PREVOST

WARRANTY BULLETIN

WB20-02

DATE :	May 2020	SECTION :	13 WHEEL, HUB & TIRES
EXPIRATION:	May 2022		
SUBJECT :	TIRE PRESSURE MONITORING SYSTEM MODULE REPLACEMENT

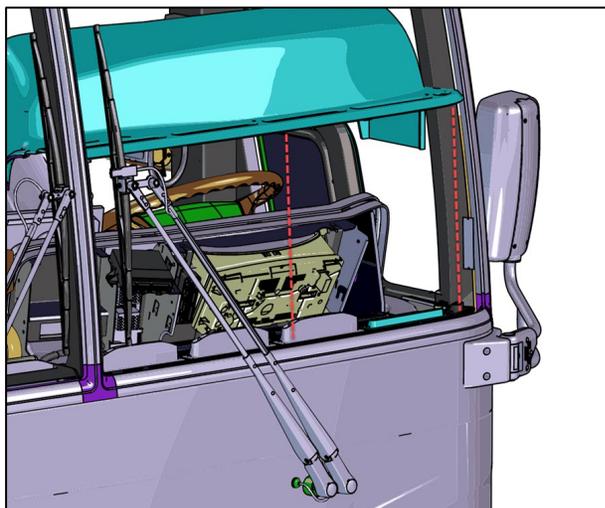
2. Disconnect and remove the existing TPMS module.
3. Install the new TPMS module #560467. This new one must have a second decal as shown on the image below, indicating it has an updated software.
